Docket Number:	21-AFC-02
Project Title:	Willow Rock Energy Storage Center
TN #:	256622
Document Title:	Willow Rock Data Adequacy Response
Description:	N/A
Filer:	Kathryn Stevens
Organization:	WSP USA Inc.
Submitter Role:	Applicant Consultant
Submission Date:	5/31/2024 10:59:07 AM
Docketed Date:	5/31/2024

Data Adequacy Responses for Willow Rock Supplemental AFC

Willow Rock Energy Storage Center (21-AFC-02)

May 2024

Figure 1
Total Annual Nitrogen Deposition
(Wet+Dry) Rates

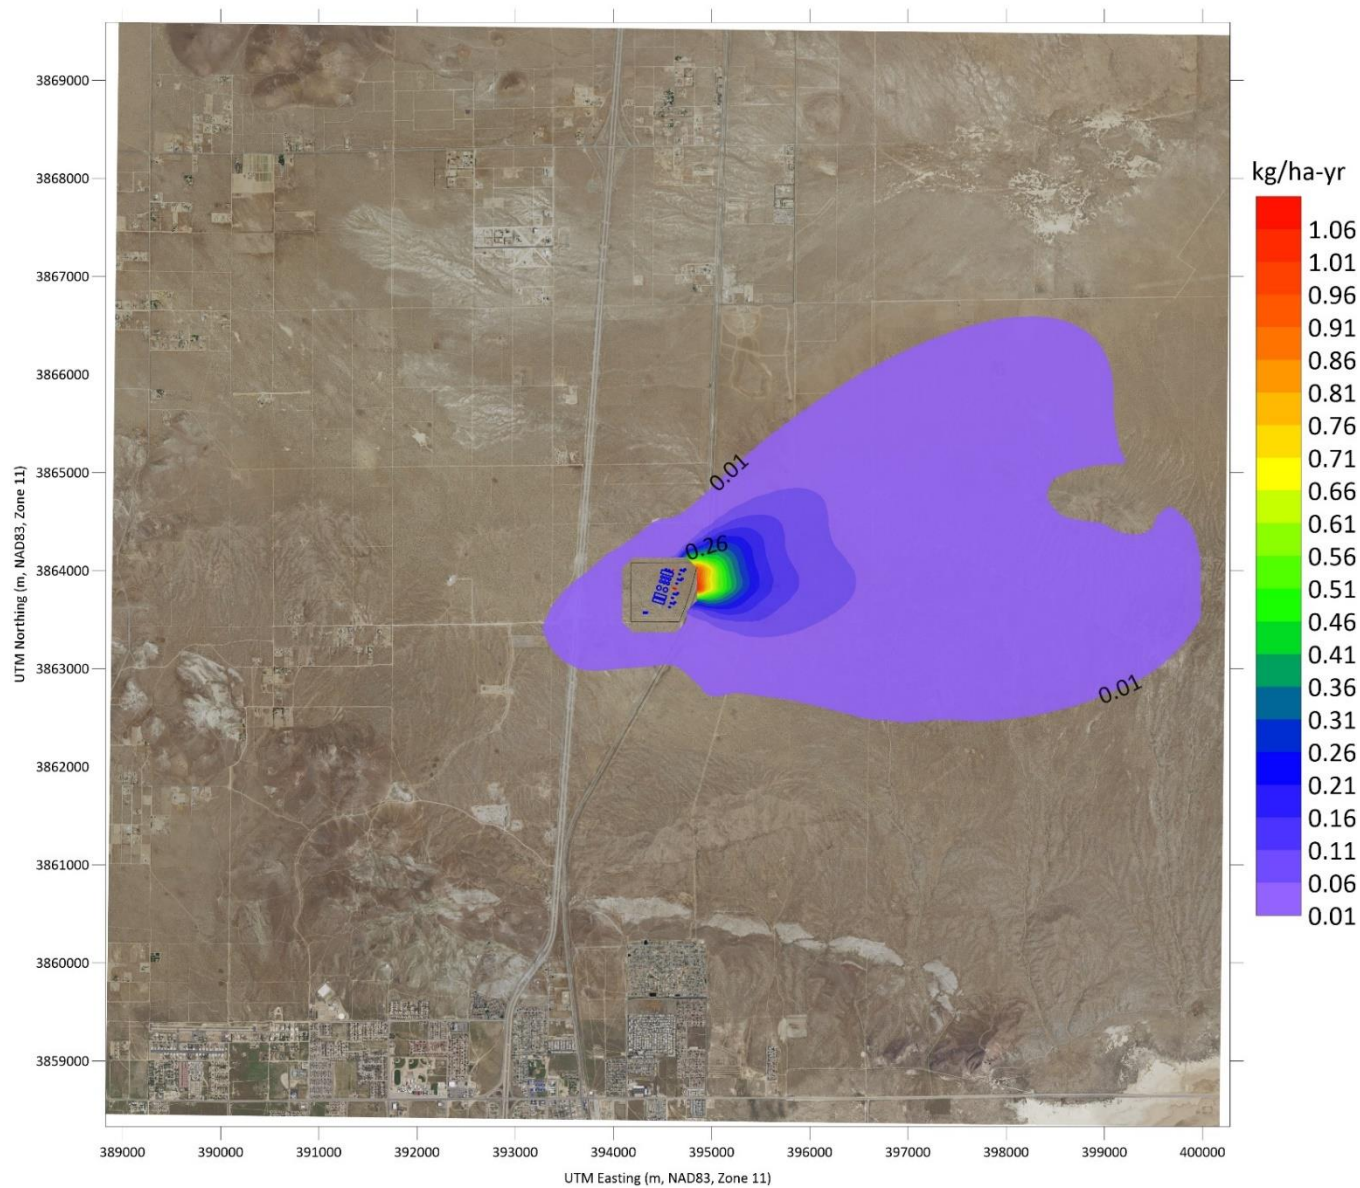
Appendix B (g) (13) (C) (iii)	Perform nitrogen deposition modeling including the complete citation for references used in determining deposition rates and location. Specify the amount of total annual nitrogen deposition in kilograms of nitrogen per hectare per year (kg N/ha/yr) in special status species habitats and vegetation types for wet and dry deposition. Describe habitat and species potentially affected.		Please provide a discussion of why nitrogen deposition is not applicable to this project, including a description of potential habitat(s) sensitive to nitrogen deposition within 6 miles of the project site.	Response BIO-3: Please see response to BIO-1, above. Attachment BIO-1 provides a technical memorandum prepared by WSP and Atmospheric Dynamics, Inc. on modeled nitrogen deposition rates. The technical memorandum is inclusive of an isopleth graphic.

The results of the nitrogen depositional modeling analysis are presented in Figure 1.

Sensitive Receptor Map
(No Berm) Operations

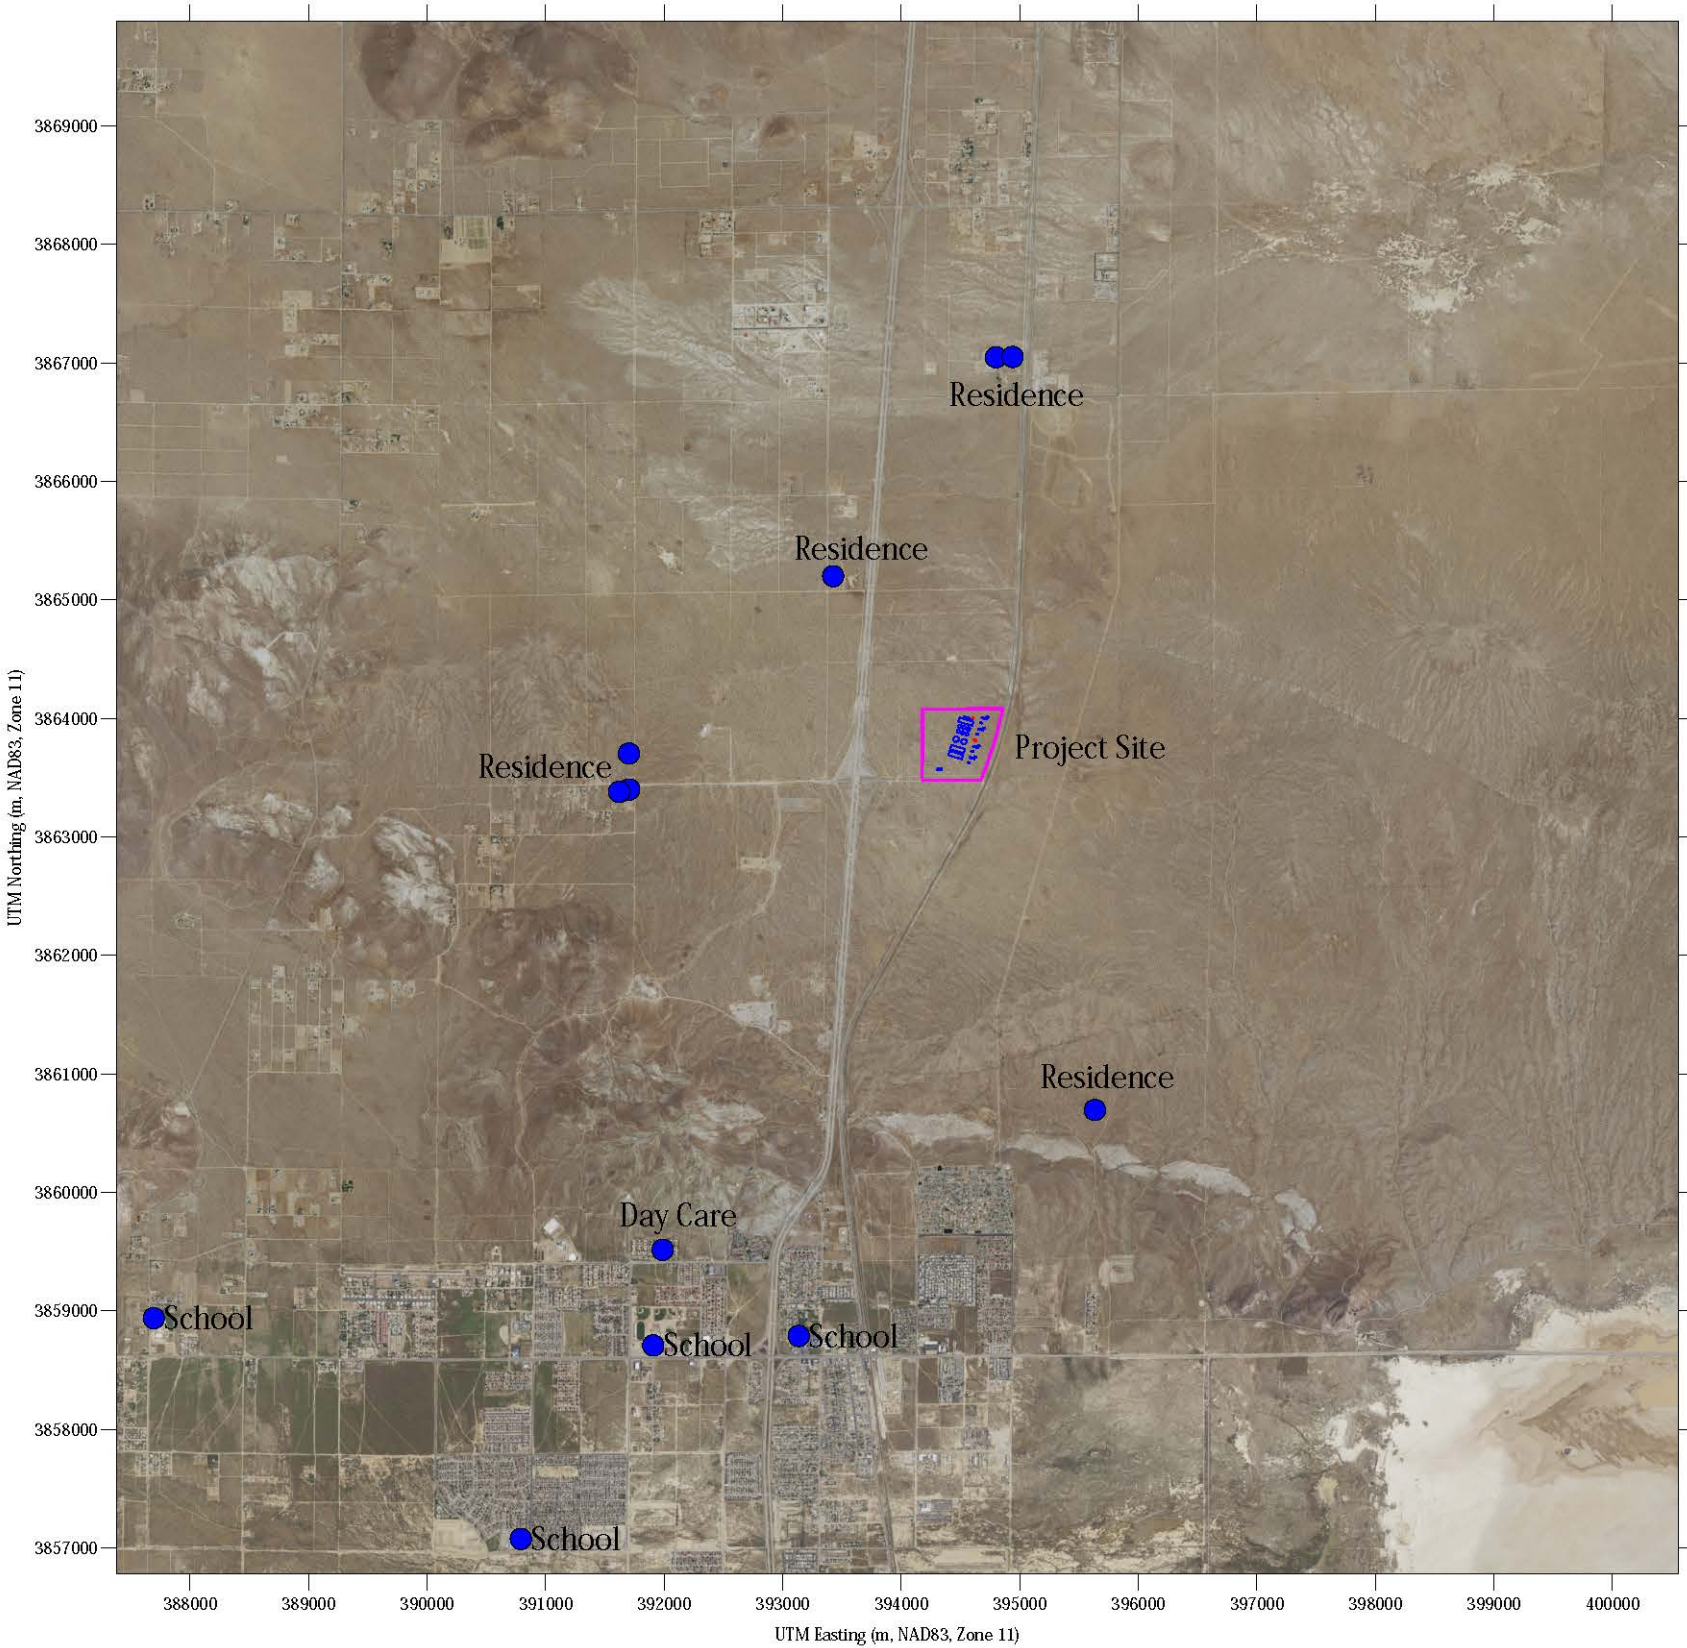
Siting Regulations	Information	Application Page Number and Section Number	Information Required To Make AFC Conform With Regulations	Data Adequacy (DA) Response
PUBLIC HEALTH				
Appendix B (g) (9) (D)	A map showing sensitive receptors within the area exposed to the substances identified in subsection (g)(9)(A).	Table 5.9-1, and Appendix 5.9A, Table 5.9A-1	Table 5.9-1 and Table 5.9A-1 list the sensitive receptors within the Project Area, but there is no map.	Response PH-1: A map of sensitive receptors is provided as Attachment PH-1 .
SOCIOECONOMICS				
Appendix B (g) (7) (A) (iii)	Existing and projected unemployment rates;	Section 5.10.2.3, Table 5.10-5, pp. 5.10-7 – 5.10-8	Provide the projected unemployment rates.	Response SOC-1: Based on a trendline from the unemployment rates for the past 5 years in Kern County, the unemployment rate in 2024 is projected to be 7.8% and 7.3% in 2025.
Appendix B (g) (7) (A) (vi)	Capacities, service standards, existing and expected use levels, and planned expansion of utilities (gas, water, and waste) and public services, including fire protection, law enforcement, emergency response, medical facilities, other assessment districts, school districts, parks and recreation facilities, libraries, and other public facilities. For projects outside metropolitan areas with a population of 500,000 or more, information for each school district shall include current enrollment and yearly expected enrollment by grade level groupings, excluding project-related changes for the duration of the project schedule.	Section 5.10.2.5, 5.10.2.6.2, 5.10.2.6.1, 5.10.2.6.3, 5.10.2.7; Table 5.10-7, pp. 5.10-10 to 5.10-11	Provide the capacities, service standards, existing and expected use levels, and planned expansion of parks and recreation facilities, libraries, and other public facilities.	Response SOC-2: Section 5.10.2 of the SAFC discusses the existing conditions, the “Affected Environment,” including subsections on population, housing, economy and employment, fiscal resources, education, public services and facilities, utilities, electricity and gas, and water. The Kern County General Plan outlines several key points regarding public service facilities, including capacities, service standards, existing and expected use levels, and planned expansion. It emphasizes the goal of providing adequate and cost-effective public services and facilities for residents and businesses. It aims to ensure that new urban development proposals and land use changes are compared to the required public services and facilities needed for the proposed projects. The General Plan indicates that recreational facilities and parks will be provided on an as-needed

Figure 1: Construction Traffic by Month

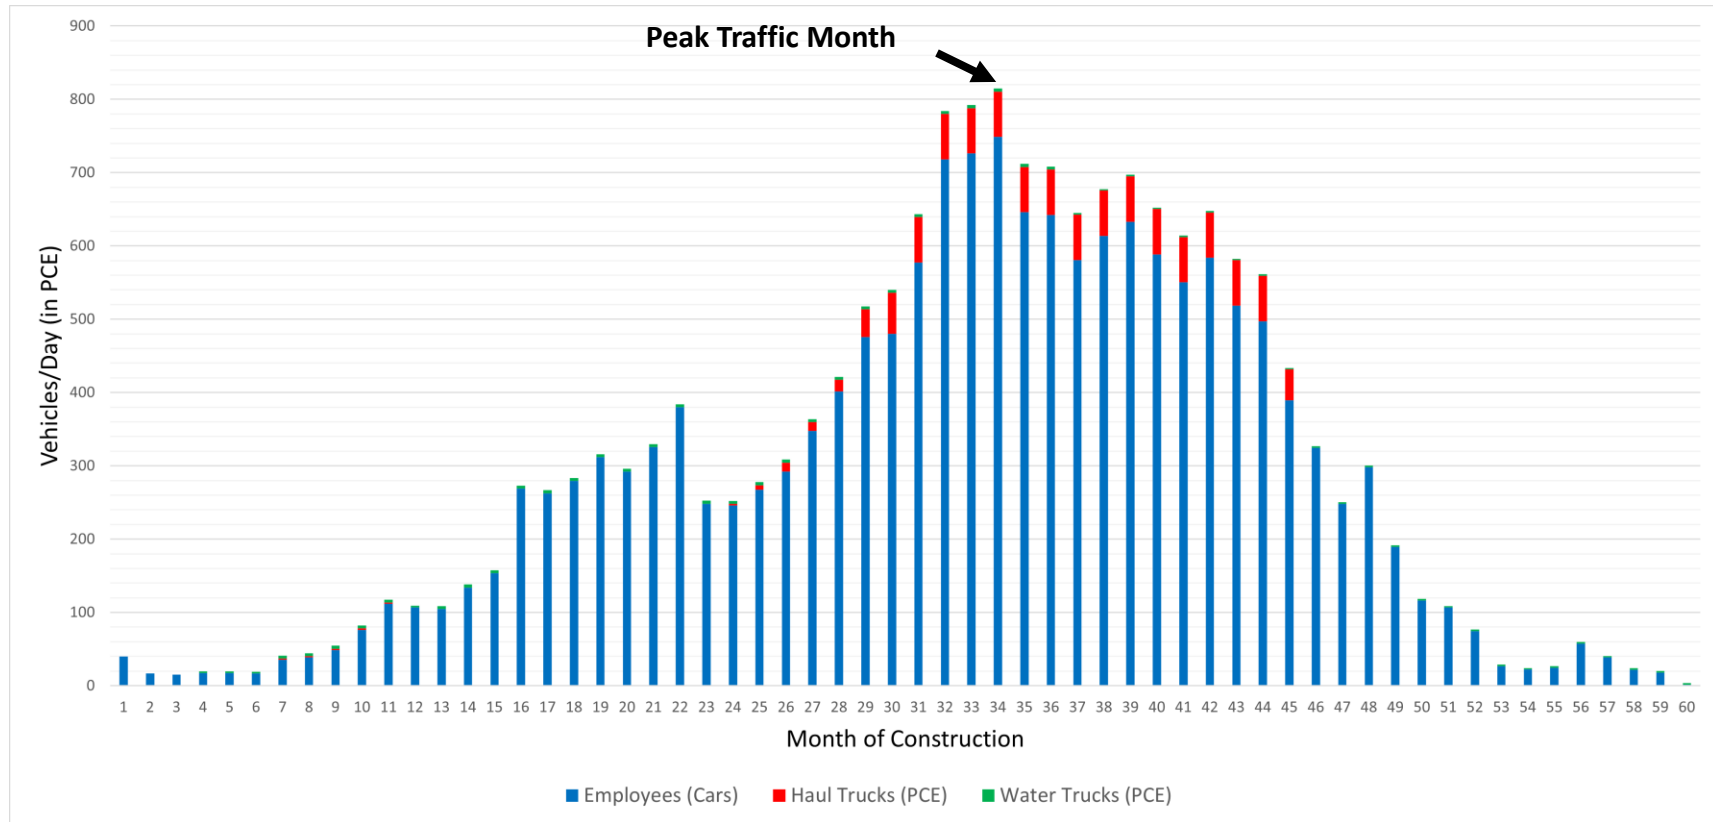
Siting Regulations	Information	Application Page Number and Section Number	Information Required To Make AFC Conform With Regulations	Data Adequacy (DA) Response
Appendix B (g) (5) (E)	An assessment of the construction and operation impacts of the proposed project on the transportation facilities identified in (g)(5)(D). Also include anticipated project specific traffic, estimated changes to daily average and peak traffic counts, levels of service, and traffic/truck mix, and the impact of construction of any facilities identified in (g)(5)(D). Include:	Section 2.12.2.2.1, pp. 5.12-9 to 5.12-10	Analysis assumptions state that all construction workers are expected to arrive to the project site during the AM peak hour and depart during the PM peak hour. Furthermore, the analysis assumes that all workers drive alone to the site. Table 5.12-2 assumes 749 workers arrive to the site during the AM peak hour and 749 workers depart the site during the PM peak hour, which suggests a total of 749 workers for the construction phase. This conflicts with the information in Figure 5.12-3 and Section 5.12.2.2.2, which estimates 1,498 total workers during the construction phase. Which is the correct number: 749 workers or 1,498 workers? If the number of construction workers is expected to reach 1,498, then the trip generation analysis summarized in Section 5.12.2.2.1 should be updated accordingly.	Response TRAN-16: Attachment TRAN-6 provides a clarification on the number of workers and worker trips during the construction phase.

The estimated number of construction vehicles per day for each month in the construction schedule are illustrated in **Figure 1**. Truck volumes have been converted to passenger car equivalents (PCE) using a factor of 2.0, which is appropriate for heavy trucks on surface streets according to the Highway Capacity Manual. The peak Project-related trips are expected to occur in month 34 with an estimated construction traffic of 815 PCE per day.
